Subject: Notification of Class 1 Permit Modification Updates Associated with the Technical Area 63 Transuranic Waste Facility Container Storage Unit of the Los Alamos National Laboratory (LANL) Hazardous Waste Facility Permit, EPA ID # NM0890010515

Enclosures: (1) Class 1 Permit Modification Notification Updates for the Technical Area 63 Transuranic Waste Facility Container Storage Unit, Los Alamos National Laboratory Hazardous Waste Facility Permit

Class 1 Permit Modification
Notification Updates for the
Technical Area 63 Transuranic Waste Facility
Container Storage Unit,
Los Alamos National Laboratory
Hazardous Waste Facility Permit

Figure 12: Metalith Barrier Plan

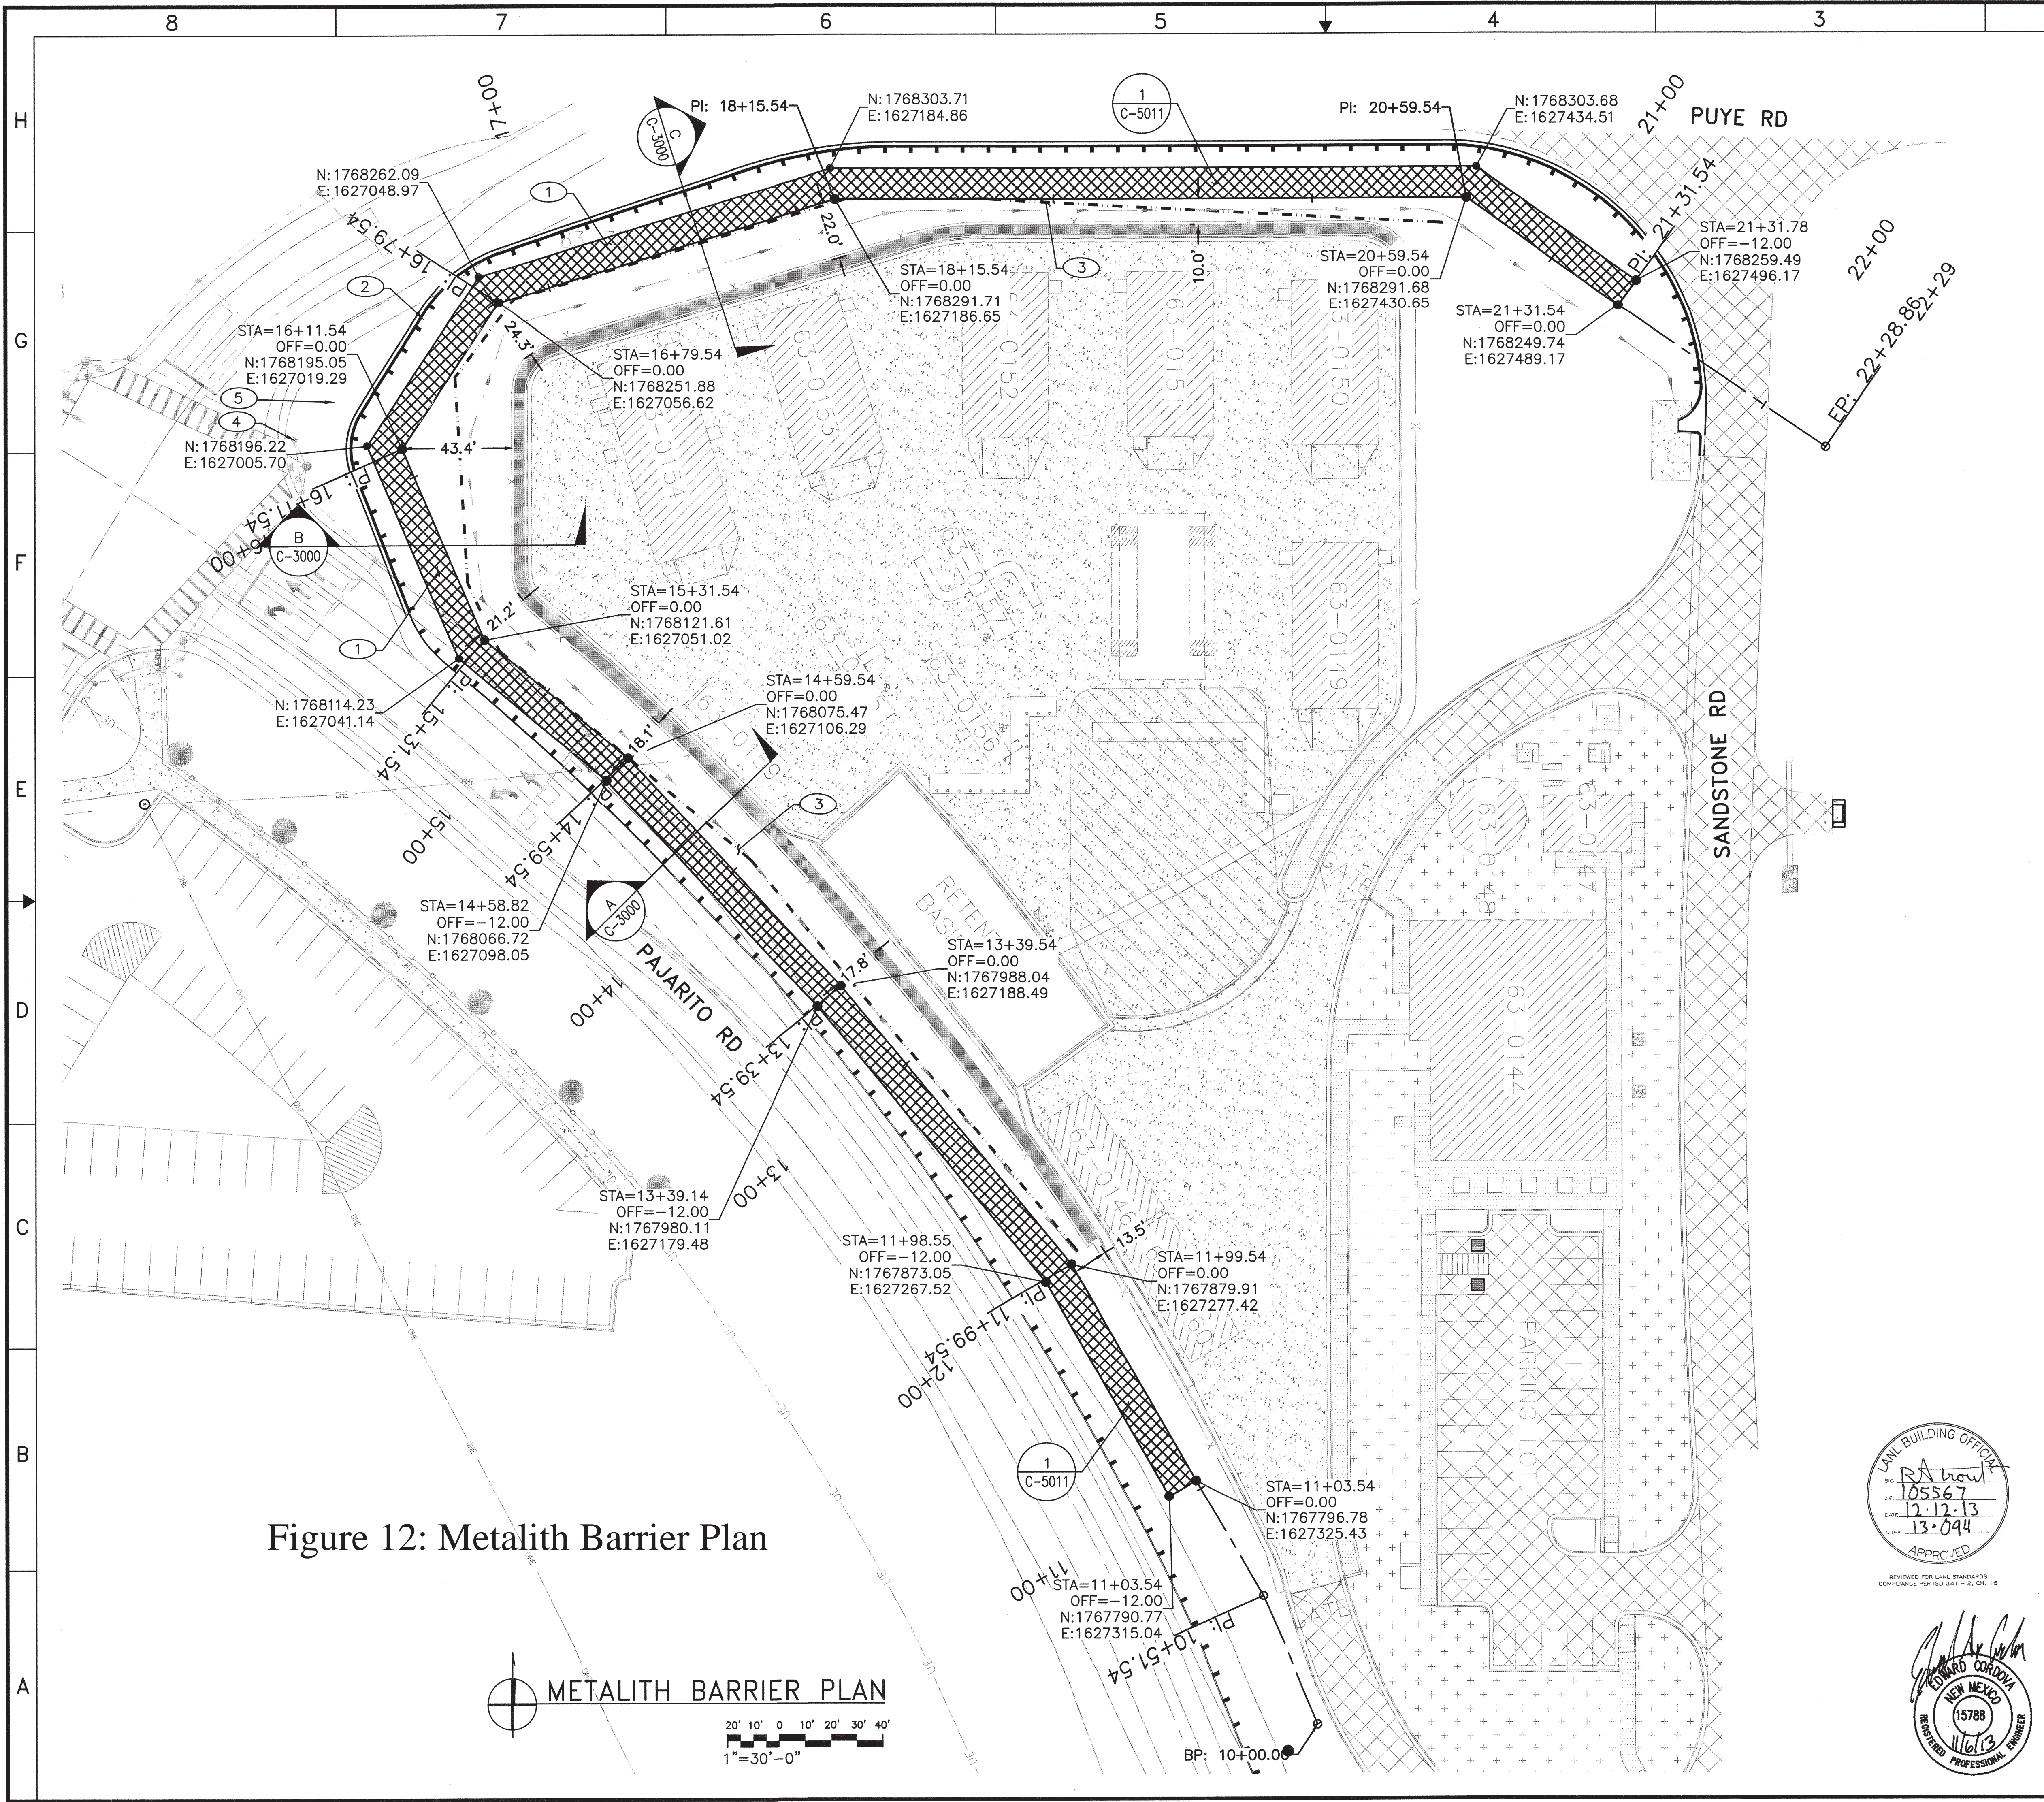
The design plan for the vehicle barriers will involve the placement of a prefabricated steel wall structure (Metalith™) as a perimeter security system along the shoulder of Pajarito and Puye Roads. The Metalith™ is a prefabricated steel barrier unit constructed from 16 and 18-gauge corrugated steel panels that are connected with stainless steel pins, and formed into multiple course assemblies resembling boxes of varying heights, thickness, and shapes. Soil or sand is then used as ballast fill in these assemblies to provide mass and support. These assemblies will be nominally 12 feet high and 12 feet wide at the TWF. They will be situated in a continuous line facing the roads with no gaps or spaces between. The line formed will be approximately 1100 feet long.

The barrier will extend along the northern part of the TWF on Puye Road to near building 63-0150 and also along the western portion of the TWF along Pajarito Road extending to building 63-0160 (*see* Figures 11-13 in Attachment 1 for more detail).

Figure 13: Metalith Barrier Sections
Note: Security Fence will be removed behind Metalith Barrier as described in Section C of the discussion.

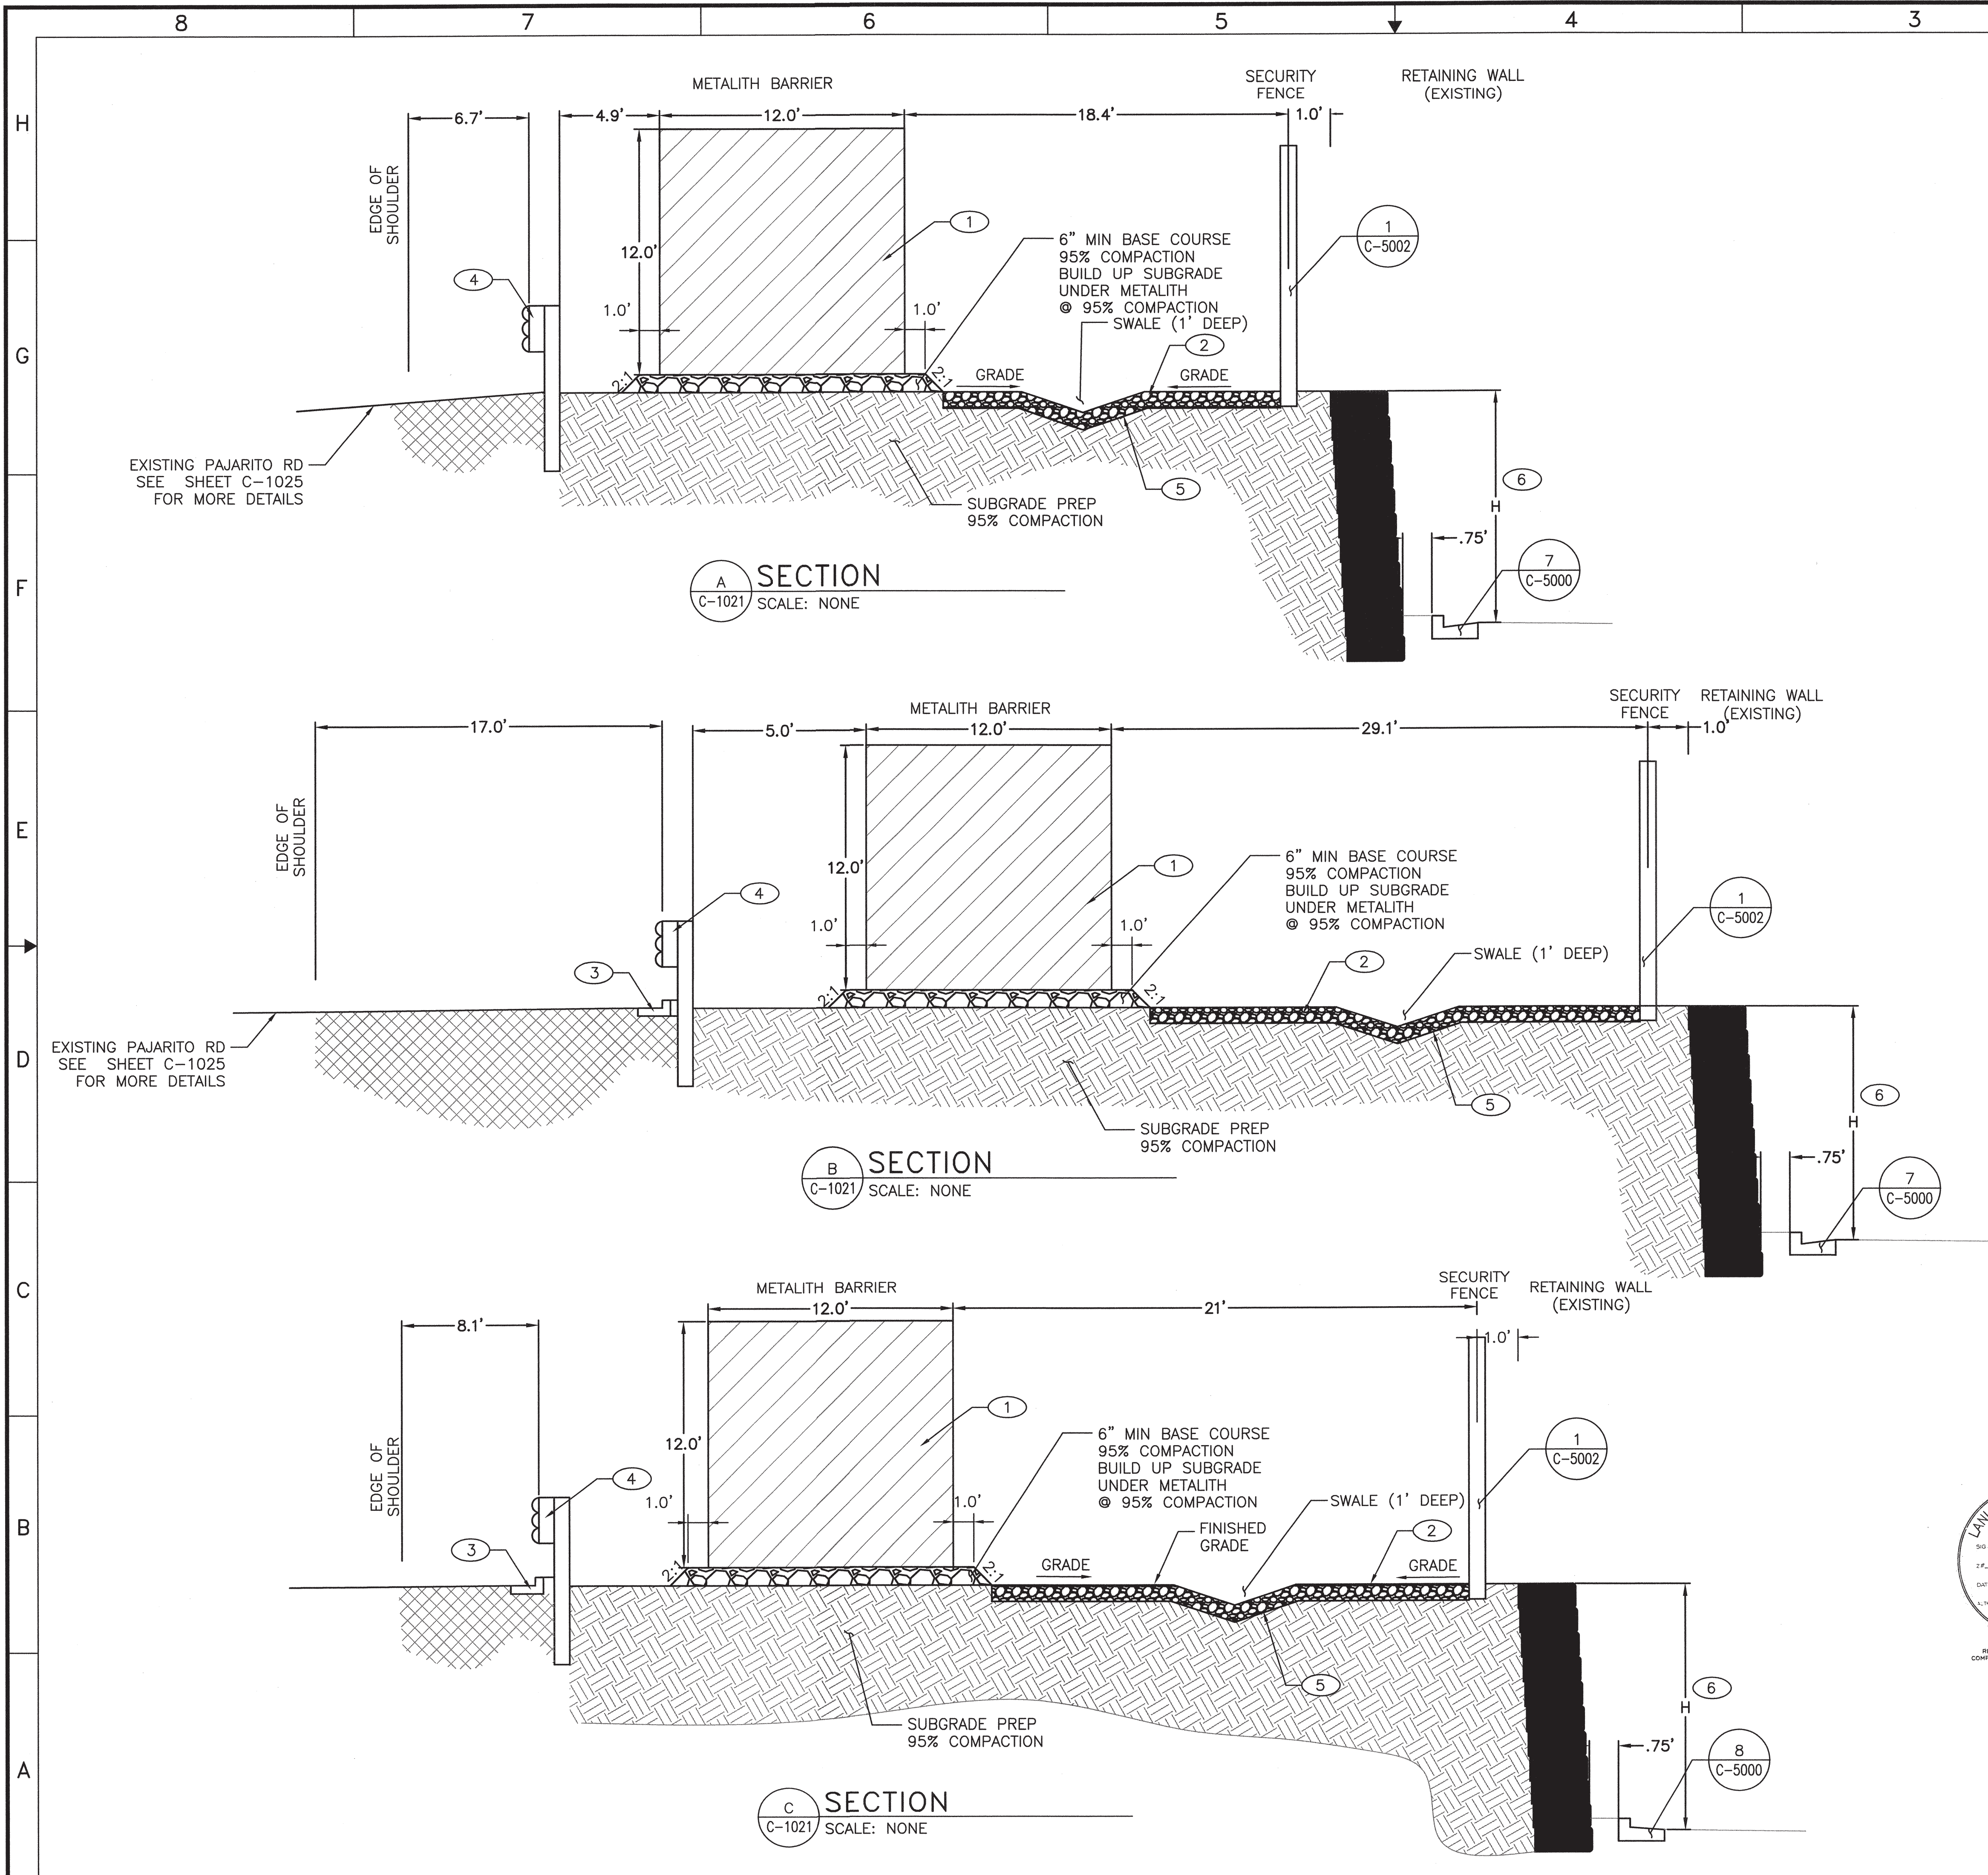
As depicted in the TWF PMR and Figure 55 of the Permit, the TWF security fence was previously shown immediately surrounding the permitted storage unit on the east, north, and west sides. As part of this permit modification notification, the position of the security fence surrounding the TWF has been partially altered to incorporate the line of the Metalith™ vehicle barriers rather than running near the boundary of the permitted unit on the sides facing the Puye and Pajarito Roads. The change has been made to improve the ability of the fence to provide protection from the entry of personnel and livestock by increasing the distance from the boundary of the permitted unit and to coordinate with and utilize the increased height of the vehicle barriers on the affected sides.
